ADDENDUM #2

Burlington School District
Integrated Arts Academy
Kitchen Project
Issued By:
Burlington School District

Issue Date: April 23, 2025

Picture of the Fire Alarm Subpanel in the stairway.

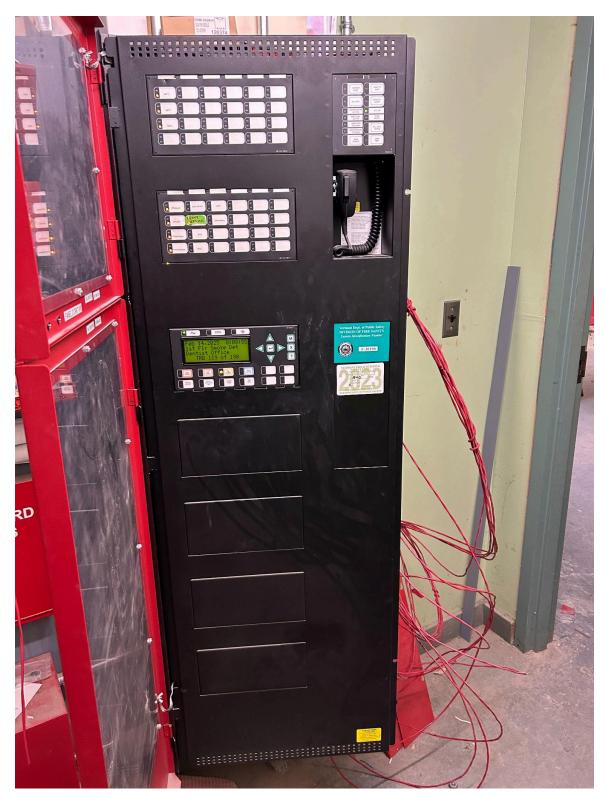
1. Will there be a walkthrough to look at existing panel/fire alarm systems? If not can detailed pictures be provided?

<u>Answer:</u> No there is not going to be a site walkthrough. We have included pictures of the Mammoth Existing Fire Alarm system. This Fire Alarm system is being fully upgraded

as part of the current project going on at the site. There are or will be existing JBoxes either in the corridor ceiling, either bathroom ceiling or the kitchen ceiling area where the Fire Alarm wiring can be accessed and extended. Refer to pictures at the end of this document of the existing Fire Alarm panels.
